Cross City Cycling: Fen Ditton Parish Council (FDPC) Response to Consultation

Ref: Ditton Lane and Links to East Cambridge

Examples of timber framed 'open' style bus shelters as replacement to existing.

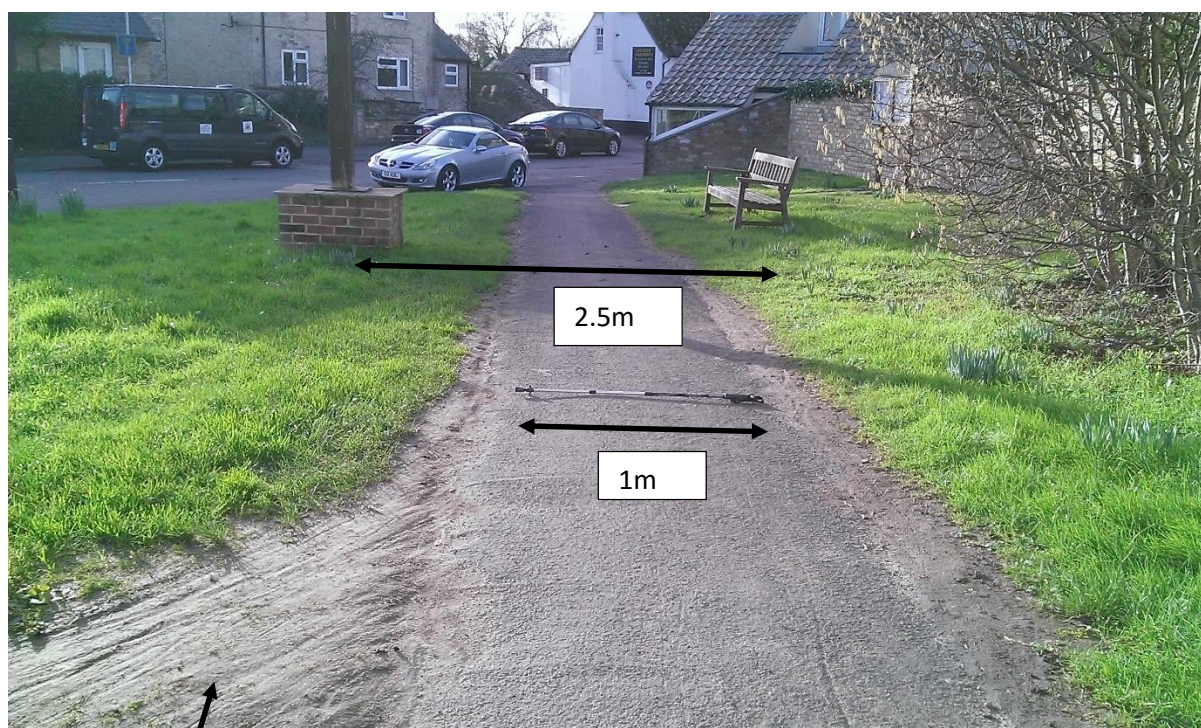
1. Replacement rather than removal of existing Bus Shelter. To replace with an alternative narrower 'open' style design in-keeping with character of Village and sensitive to conservation area ie timber structure not urban design. Requires sufficient roof line for 8 to 10 to benefit from some shelter. Ideally to sit behind or offset to new footpath but, if necessary on it, hence recommendation of a narrow construction.

Narrow base takes limited space on path but limited no's can shelter

Wider base would offer more shelter but take up more space on path.

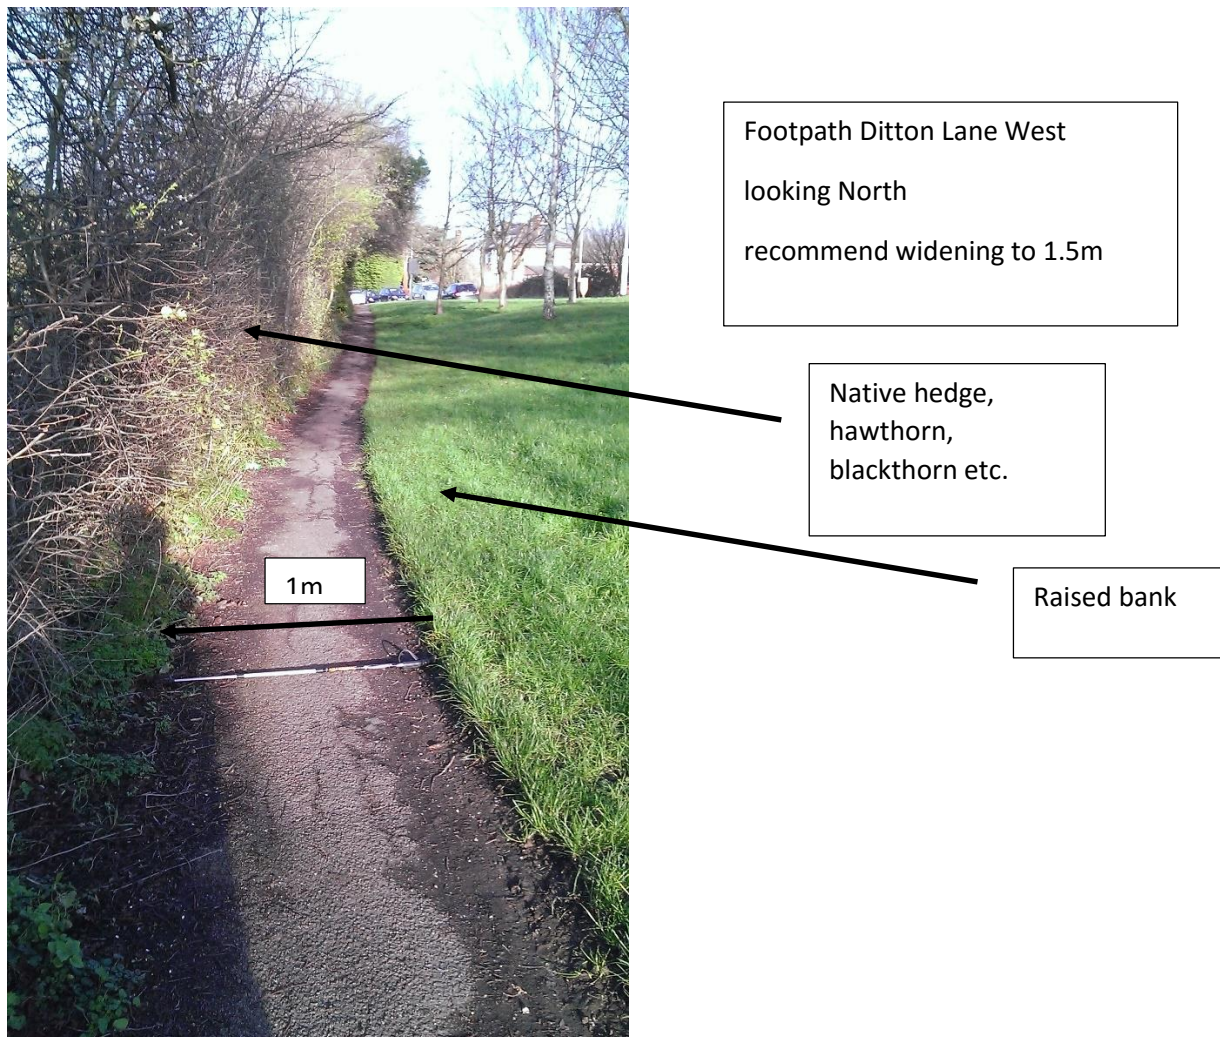
- i) Retain as much of the grass bank and slope as possible
- ii) Review the feasibility of a retaining wall and or reduction in depth of the bank in the light of containment of the run off from the Paddock and unintended environmental consequences.

- iii) Ensure any engineering works secure the bank in place to prevent erosion and problematic run off/soil deposits on new path and include sufficient replacement top soil to enable sustainable re-planting.

- iv) In the case of the use of engineering bricks to minimise this e.g. 3-4 courses. Colour to be in-keeping and sympathetic with existing village walls i.e. muted colours, e.g. 'Cambridge Brick' (see Fen Ditton Conservation Policy). NOT red and black engineering bricks!!

- v) To retain existing Rowan Tress if possible, if not, as proposed to replace the same species on top of the bank.
- vi) Replacing existing original council concrete post and wire fencing with wooden post and rail fencing as per North side of field to enhance landscape and amenity value.

- vii) If existing Rowan Trees are to be lost and replacement planted on top, a new planting scheme in the grass bank, for example naturalised spring bulbs or strips of wild flowers of value to insects etc., to be incorporated into the scheme.
